The Commission has issued the enclosed Amendments Nos. 32 and 36 to Facility Operating Licenses Nos. DPR-24 and DPR-27 for the Point Beach Nuclear Plant, Units Nos. 1 and 2. The amendments consist of changes to the Technical Specifications and are in accordance with your application dated July 28, 1977 as revised by letters dated October 5 and December 12, 1977.

POINT BEACH NUCLEAR PLANT, UNIT NO. 1

Amendment No. 32
License No. DPR-24

ATTACHMENT TO LICENSE AMENDMENT NO. 32

Figure 15.6.2-4

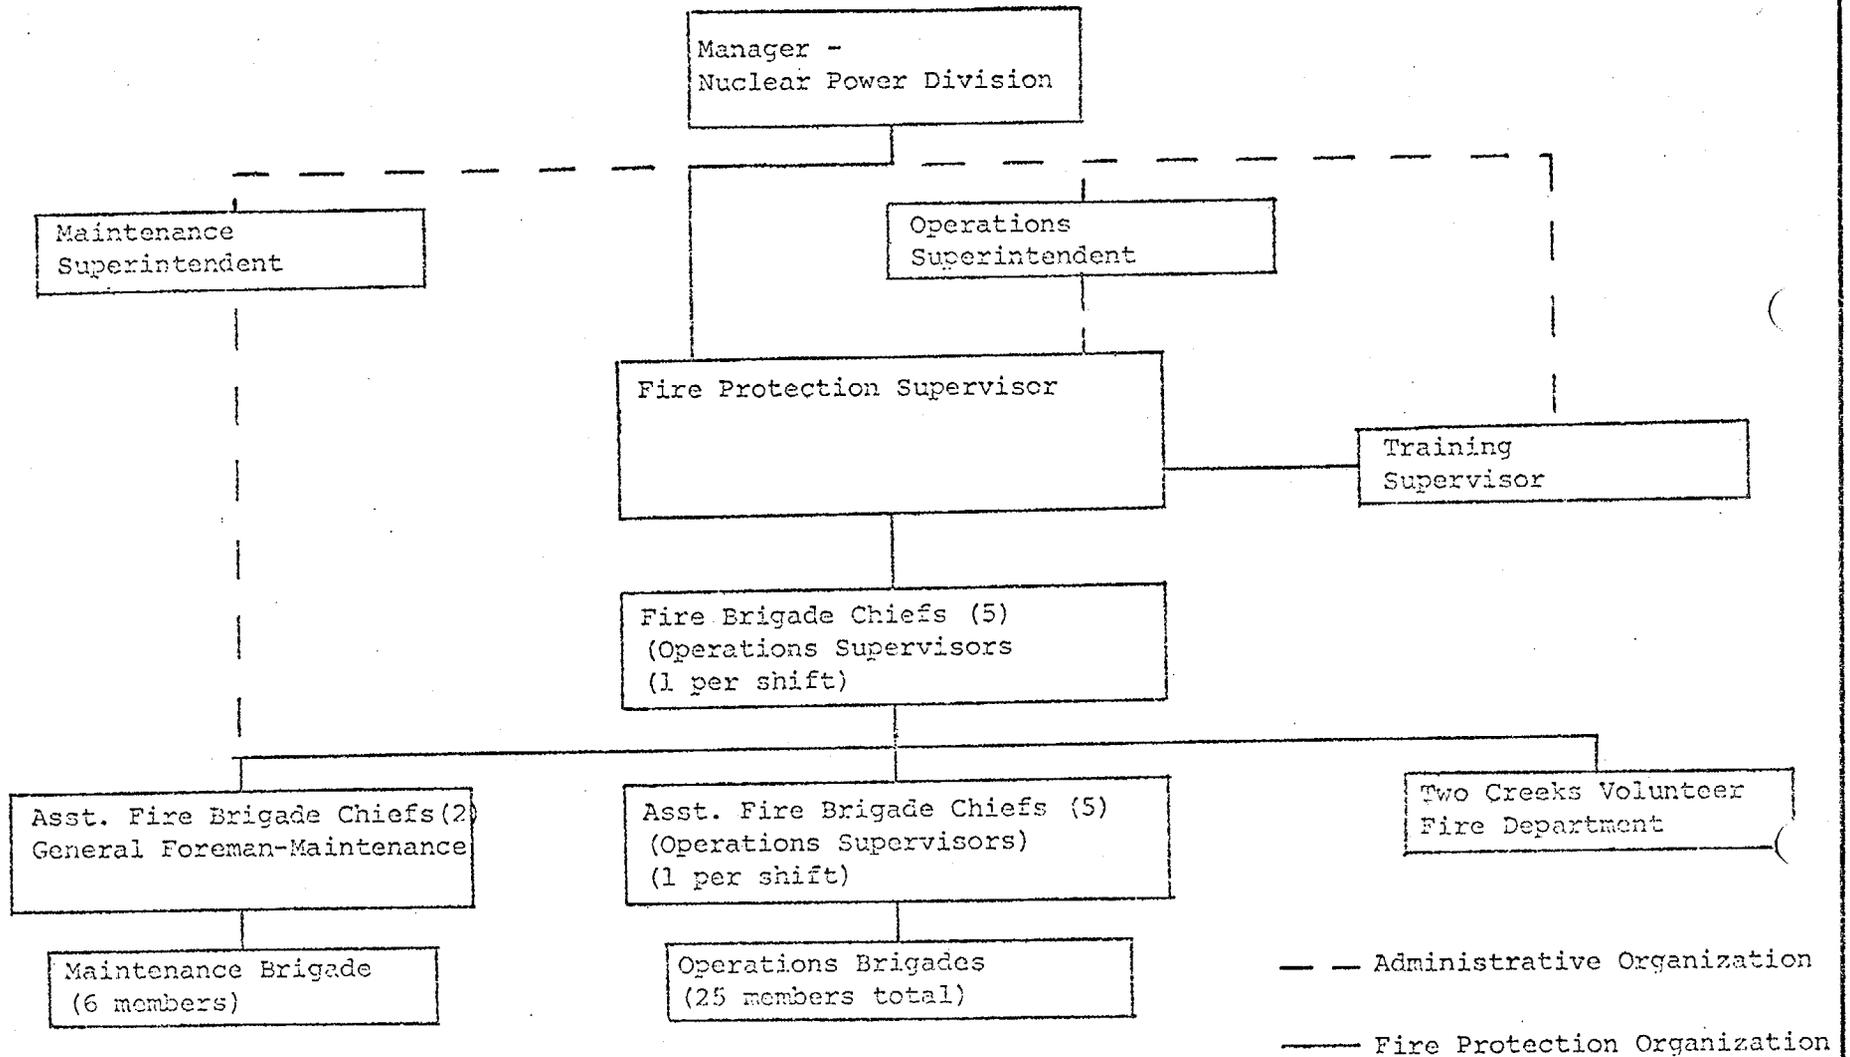
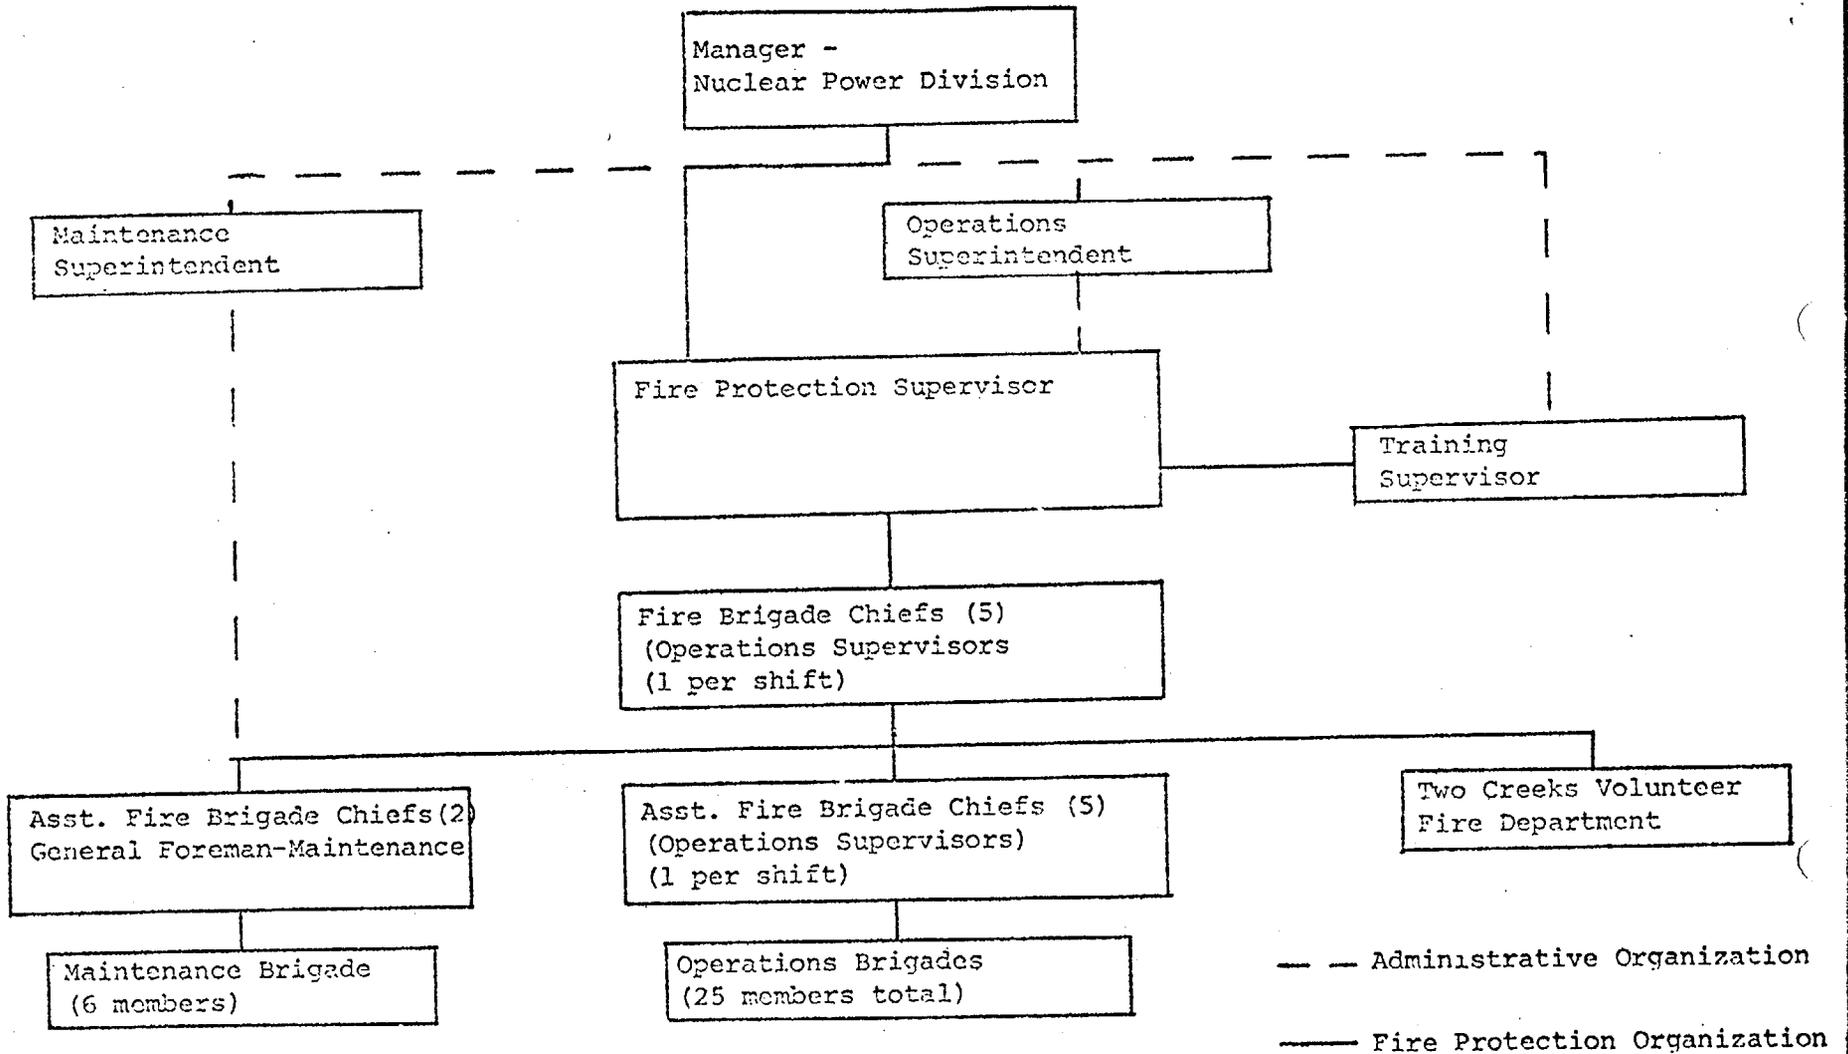
These amendments revise: (1) Specification 15.6.4.2 to reflect the title change of the Fire Protection Supervisor (the title had been Fire Protection Program Manager), (2) Figure 15.6.2-4 to indicate the Fire Protection Supervisor is no longer the Assistant to the Operations Superintendent, and (3) Specification 15.6.8.1.8 to clarify when the fire protection procedures must be provided (as agreed to by the licensee). Since these revisions are administrative matters, the staff finds them acceptable.
